## Connah's Quay Low Carbon Power

# Applicant's Response to Report on the Implications for European Sites

Document Reference: EN010166/APP/9.35

**Figure 2: Proximity of A548 to the Dee Estuary SSSI/SPA/Ramsar (Source Magic.defra.gov.uk)**

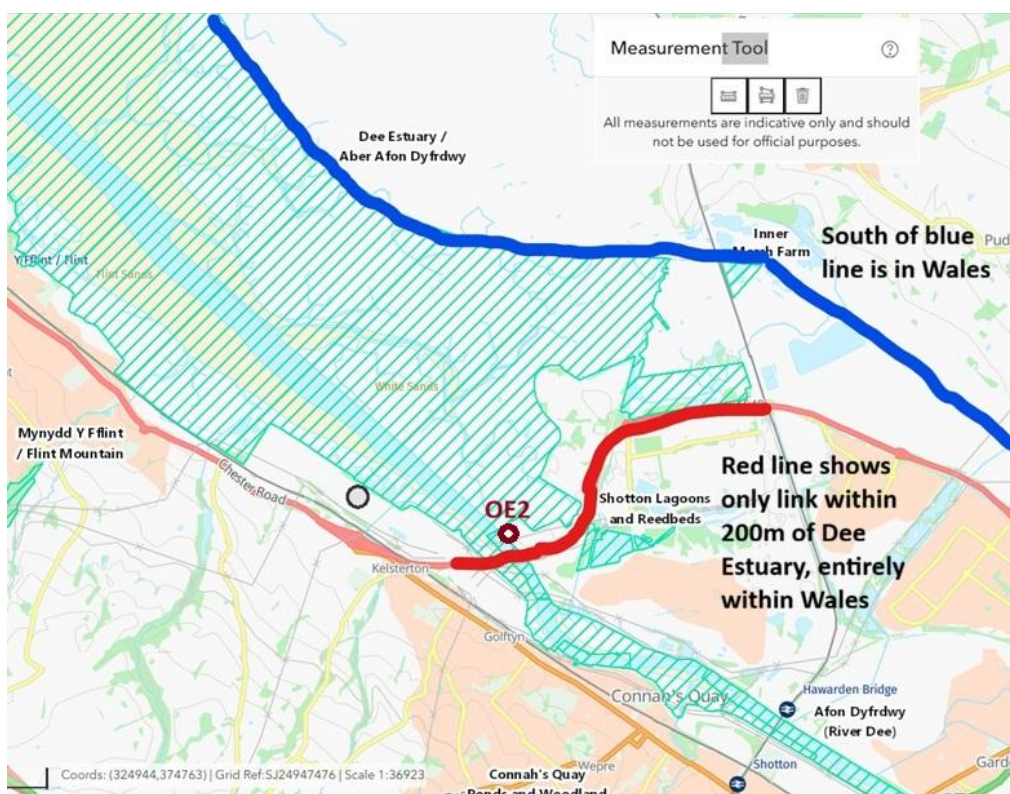
- ***Point 3.10 – ‘Natural England notes the Applicant’s explanation [regarding the traffic impact on the Dee Estuary SAC on transects TE8a to TE8c]. Previous comments broadly remain regarding the ecological interpretation of deposition impacts on qualifying saltmarsh habitat and the associated conservation objectives’.***

- 2.3.1 The only place where Dee Estuary SSSI/Special Protection Area (SPA)/Special Area of Conservation (SAC)/Ramsar site lies within 200m of a road to be used by construction traffic is located entirely in Wales, where the A548 Weighbridge Road crosses the River Dee (Flintshire Bridge) as shown in **Figure 2**. This has been modelled as transects TE8a to TE8c and reported in the **Report to Inform Habitats Regulations Assessment (RIHRA) [REP5-030]** (paragraphs 10.2.25 to 10.2.26). This is also the location for operational modelling location OE02 and its associated 1km grid square, again entirely within Wales. The only notable source of ammonia within the grid square used for background ammonia is the A548. It would be reasonable to assume background concentrations of ammonia are homogenous across the remainder of the square.

- 2.3.2 Natural Resources Wales (NRW) have not raised any issues with the assessment. Since this applies entirely to a part of the designated site in Wales, the Applicant assumes Natural England are content to defer to NRW as suggested in their comments raised at Deadline 5. If so, this would therefore resolve Natural England's points 3.4, 3.7, 3.10 and 3.11 raised at Deadline 5 as these all relate to receptor OE02 and transects TE8a to TE8c, located entirely in Wales.

Figure 5: Proximity of Mersey Estuary SPA/Ramsar to the Proposed Development (Source [magic.defra.gov.uk](http://magic.defra.gov.uk))

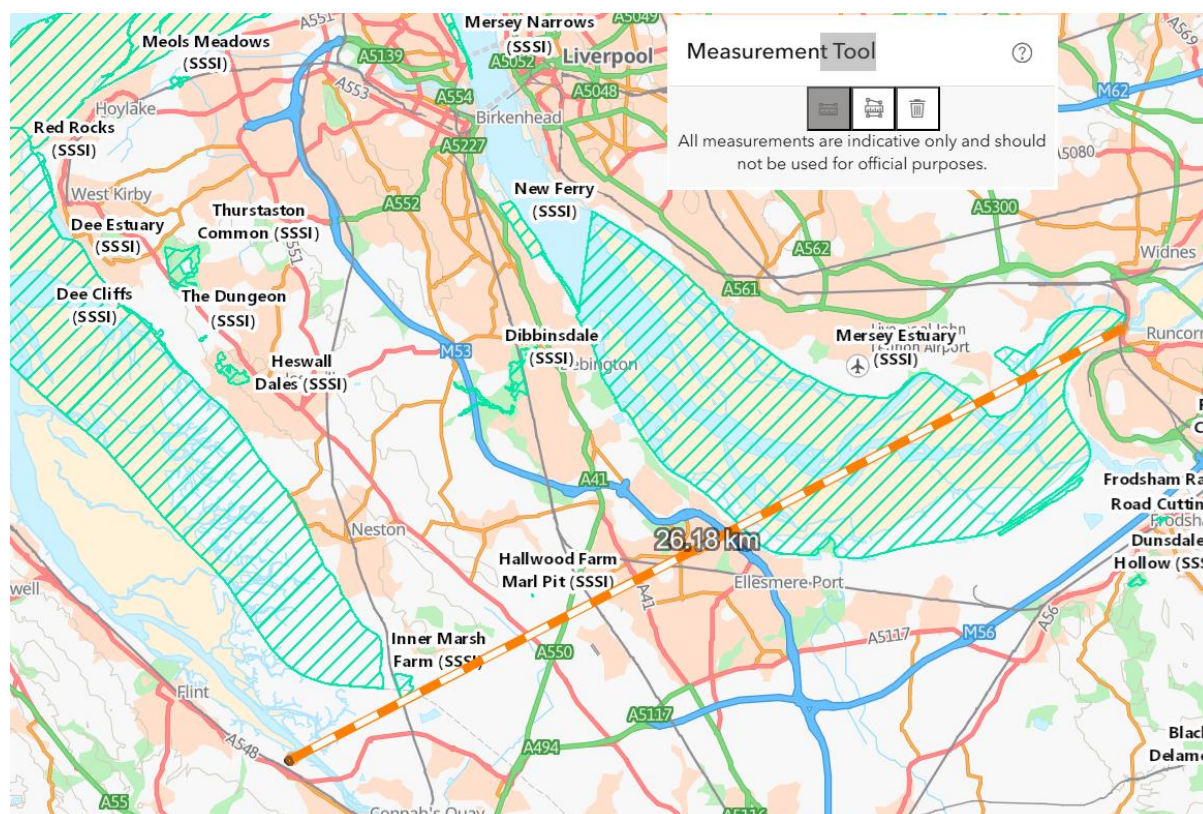
- **Point 3.3 – ‘Please provide clear evidence to support the conclusion that no relevant affected road links fall within the applicable screening distance of the Mersey Estuary SPA / Ramsar.’**

2.6.1 As shown in **Figure 5**, the Mersey Estuary SPA/Ramsar site is located 26km from the Proposed Development at the only point the SPA/Ramsar site lies within 200m of a significant road (the A557 Silver Jubilee Bridge between Runcorn and Widnes). This is remote from the M56 which would be the main route for construction traffic to reach the Proposed Development and is also a toll bridge.

- As explained in Section 2, the Mersey Estuary SPA does not lie within 200m of any roads which would be used for construction traffic.
- **Point 3.4 – ‘To conclude this point for English [Dee Estuary] designated habitat, please provide confirmation of whether the assessed receptors**

**SHEET TITLE**  
Outline Surface Water Drainage Strategy  
General Arrangement

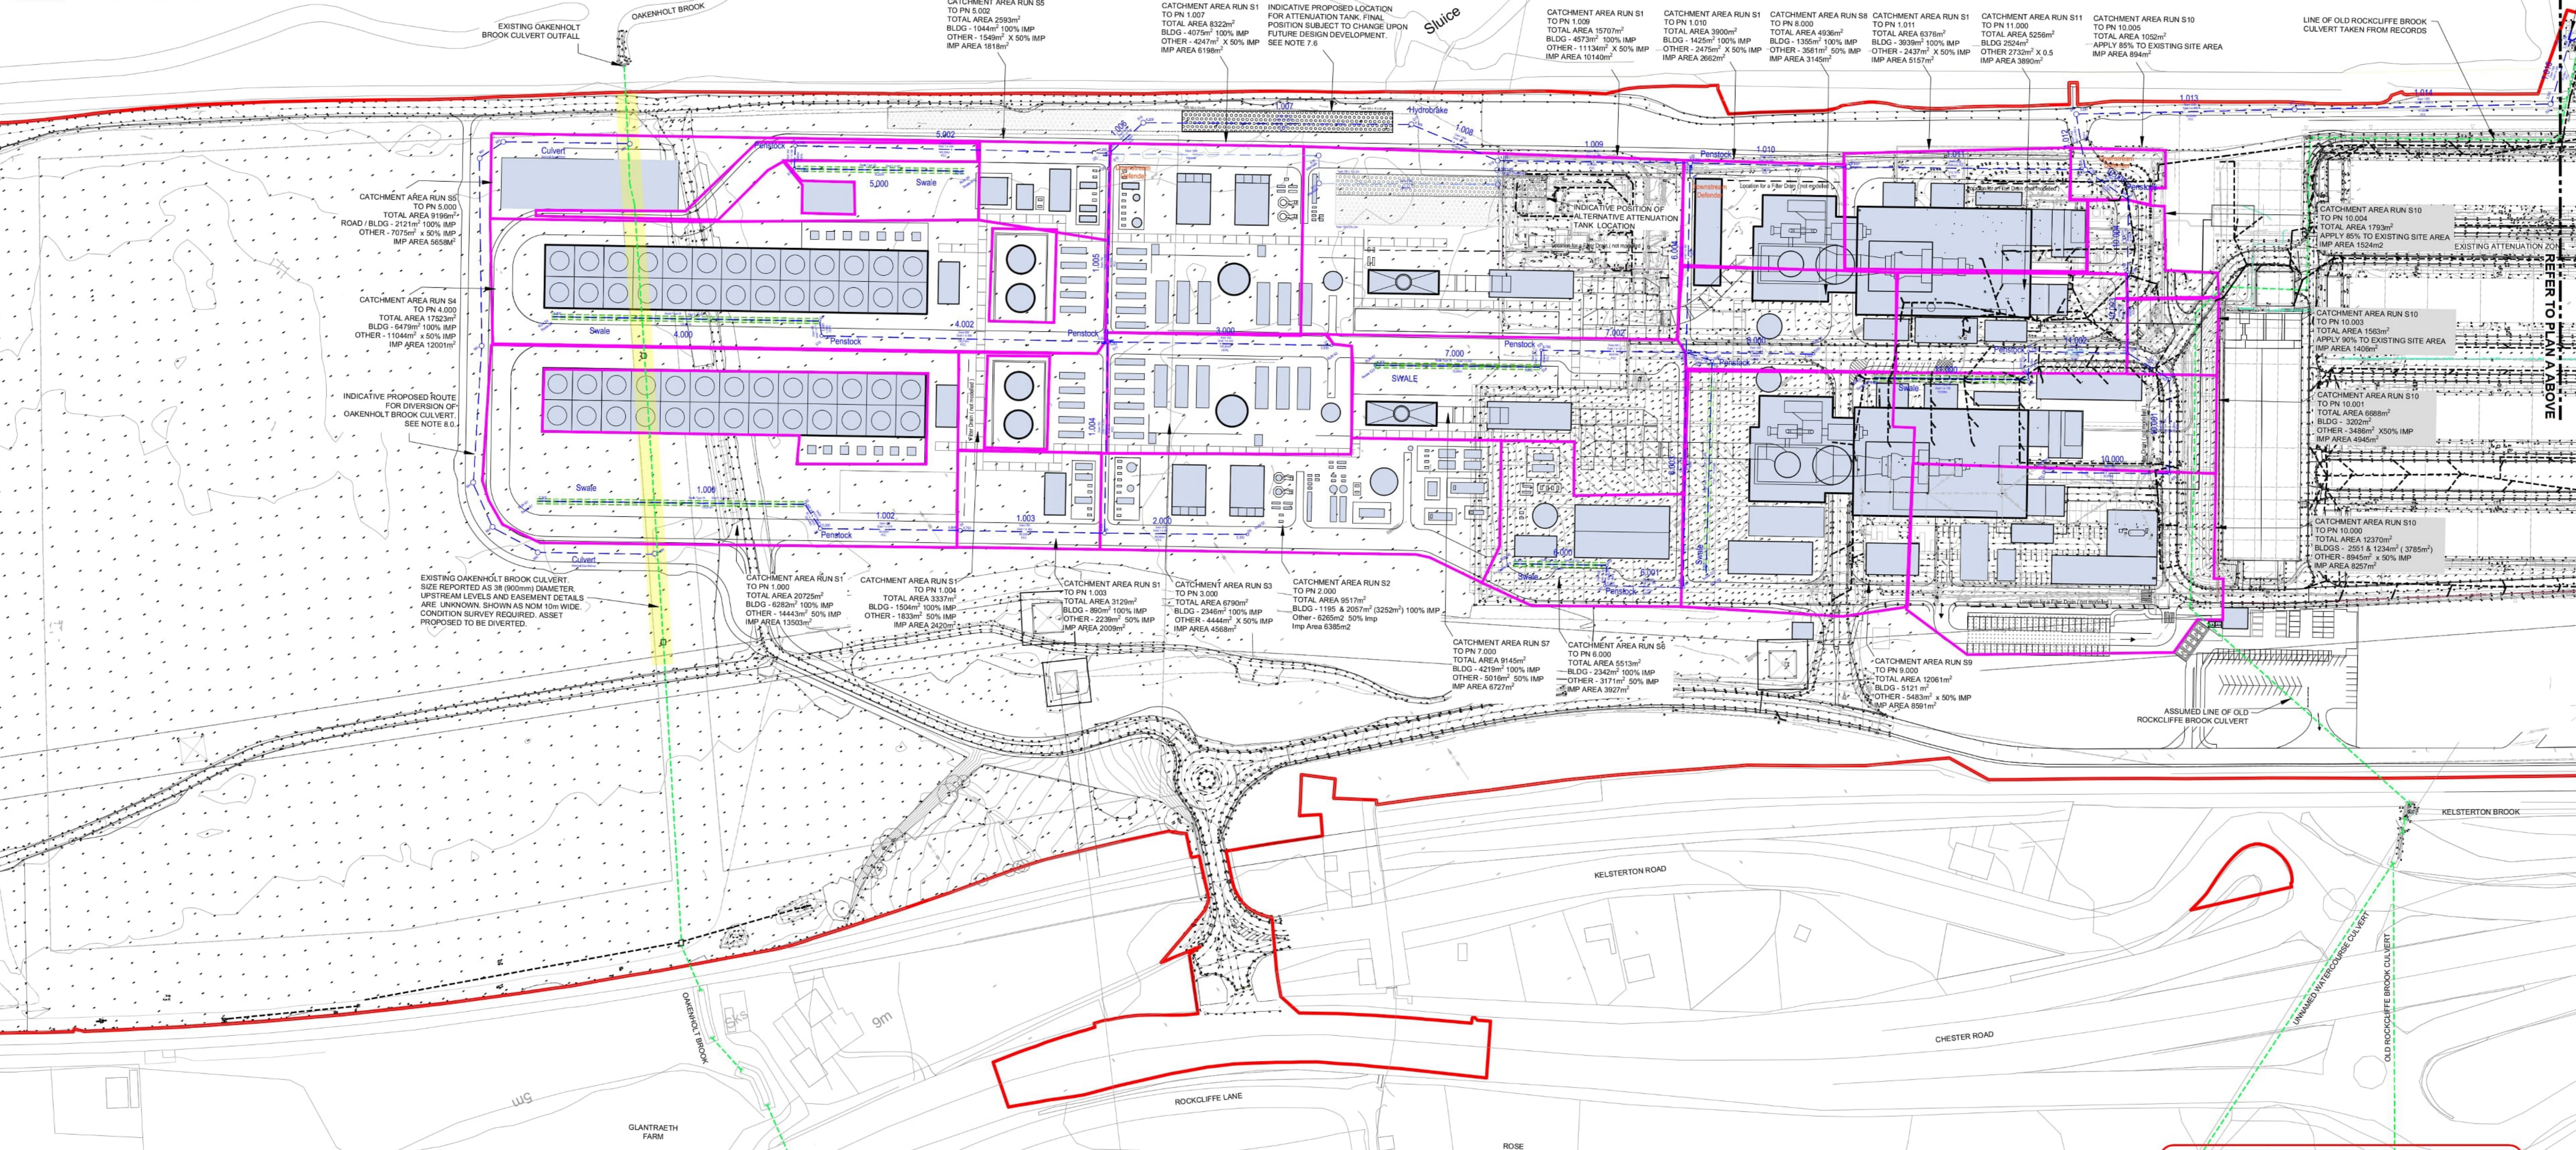
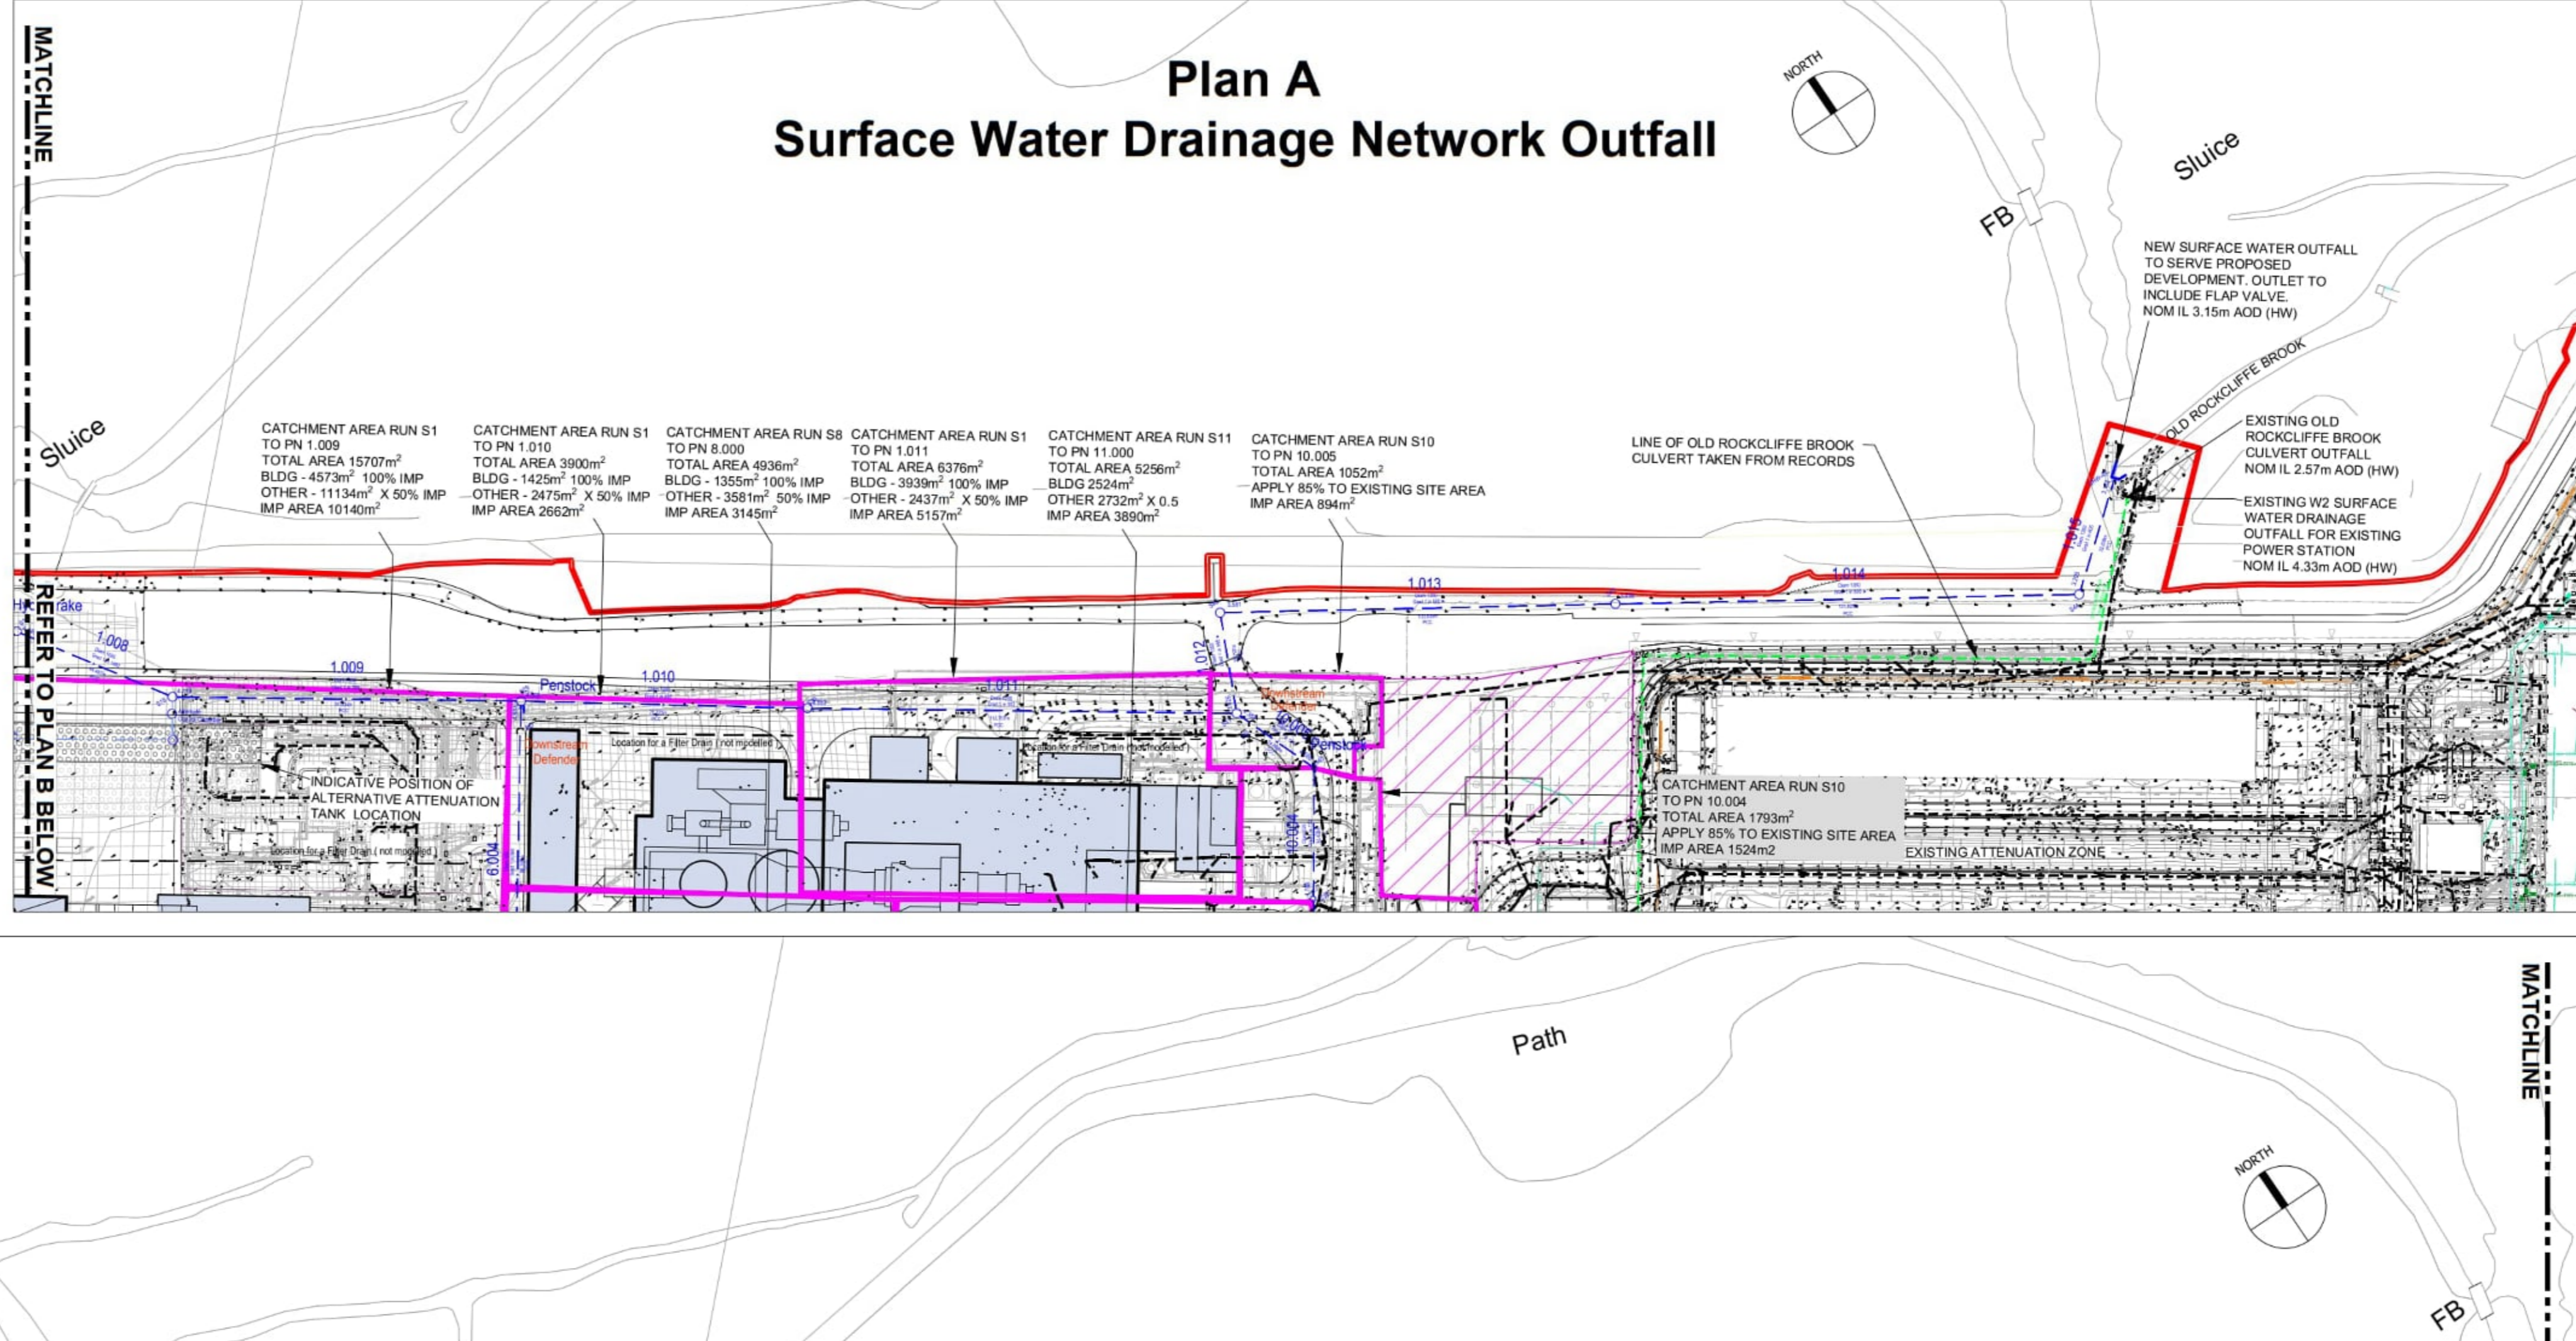
| Reference | Question to                    | Source Document Text   | Topic | Applicant's Response   |
|-----------|--------------------------------|--|-------|--|
| RQ.34     | The Applicant                  | <ul style="list-style-type: none"> <li>a) Clarify the location and amount of the outfall pipe likely to be buried and where the above ground locations would be.</li> <li>b) Update the RIHRA to include the results of the GWSR.</li> </ul>   |       | <ul style="list-style-type: none"> <li>a) The location of the outfall pipe would be entirely within the Surface Water Outfall Area as shown in Annex G of <b>Appendix 13-D: Outline Surface Water Drainage Strategy [REP4-038]</b>. The length of pipe that would be buried within the Dee Estuary SAC is approximately 35 m until reaching the proposed headwall. Annex G is provided in full in <b>Appendix C</b>, however, a zoomed in image of the relevant map is provided below with the proposed drainage infrastructure shown in blue and the existing drainage infrastructure shown in black. With the exception of the headwall all infrastructure shown in this image is sub-surface:</li> </ul>  |
